Z-31  
(2014)

**PETITION NO:** Z-31

### **Z-31 DCG PEBBLEBROOK, LLC**

Planning Staff Analysis

LOT INFORMATION  
C.010

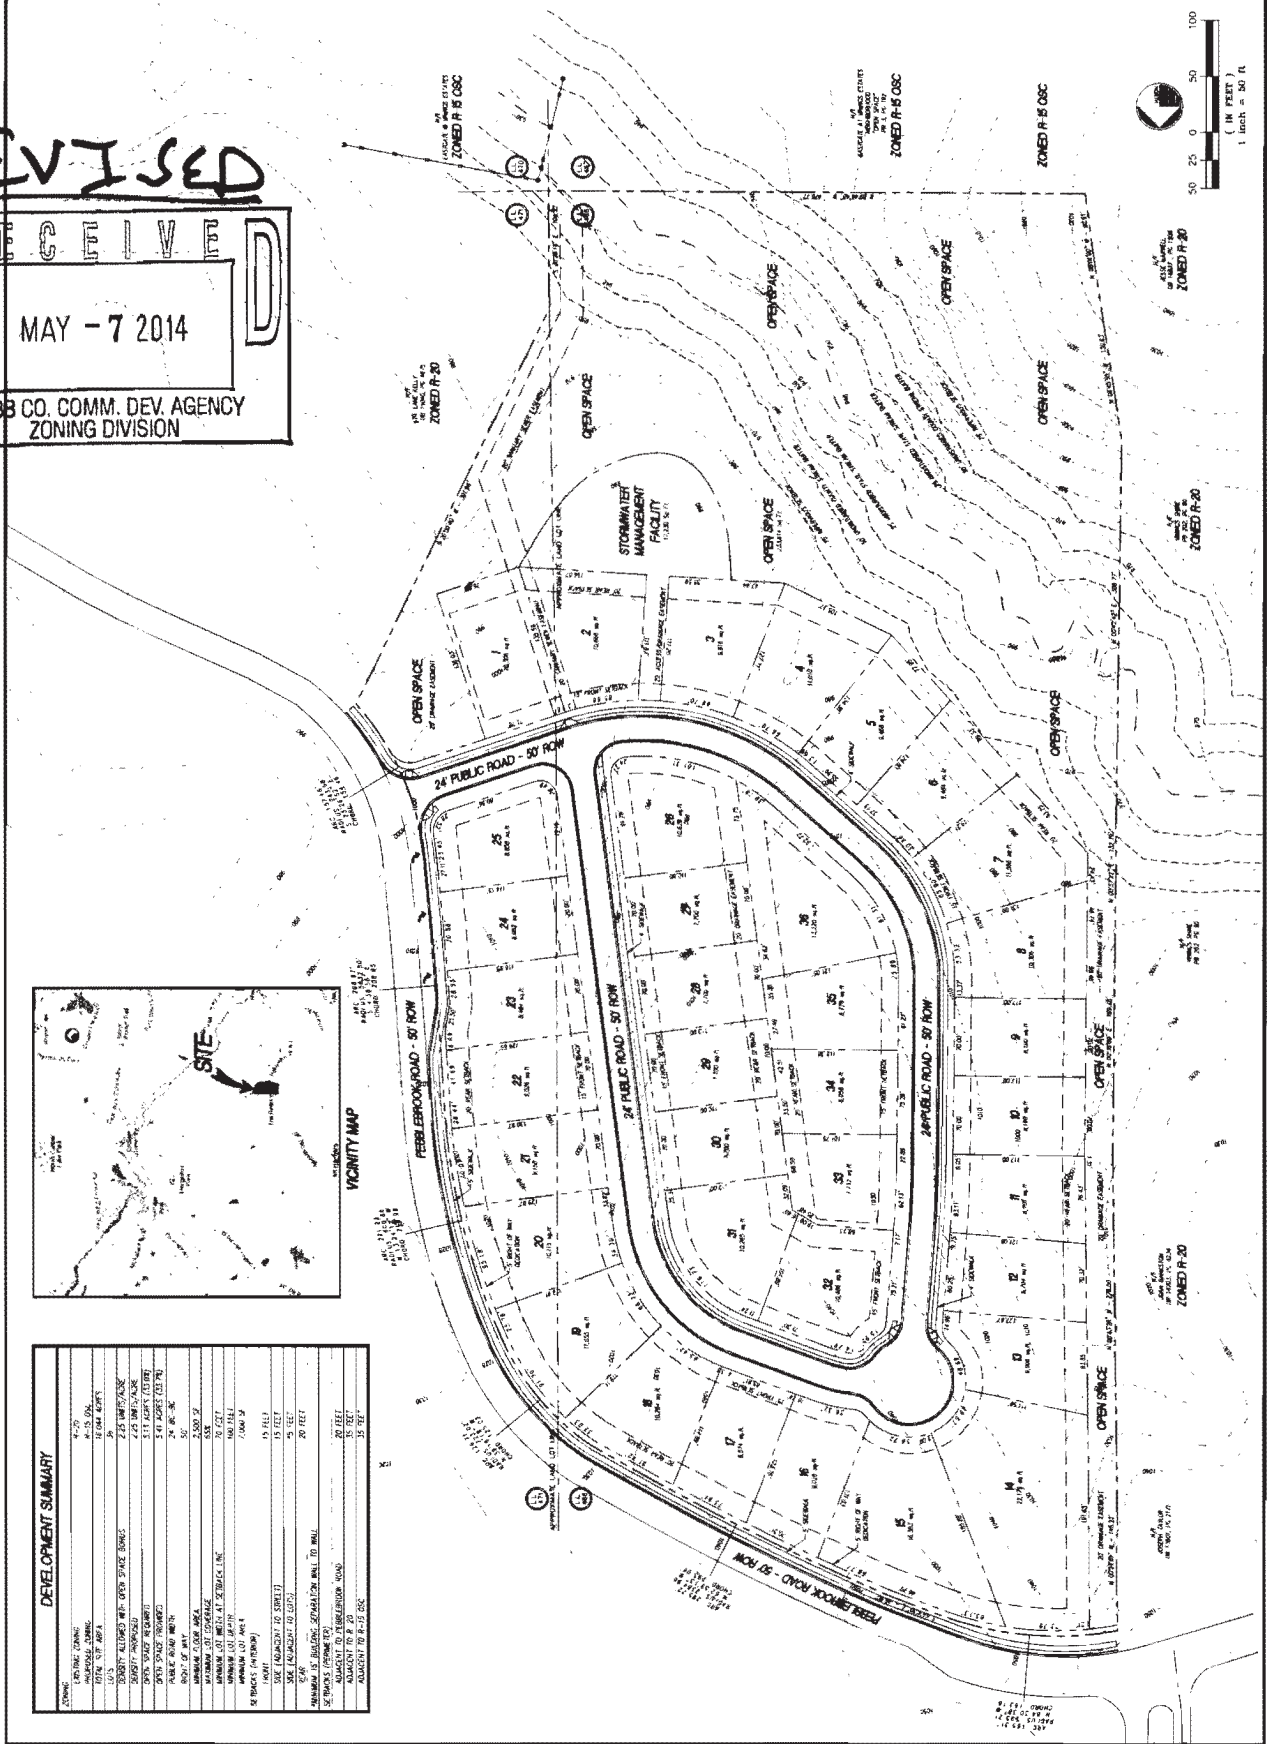
1. This site is located to the south of Pebblebrook Road. The entire site drains to the southeast via an unnamed tributary to Nickajack Creek. The proposed site plan places the rear third of the parcel including all the stream buffer area within designated open space. The proposed detention pond is well-located within the area previously occupied by the original homestead. Based on the proposed layout, a drainage easement will likely be required along the rear of lots 1 through 14 to convey site runoff to the detention pond.
2. Due to the steepness of the existing topography elevated erosion control measures should be utilized. It is recommended that a mulch berm be placed along the southerly limit of disturbance in addition to the required silt fencing.
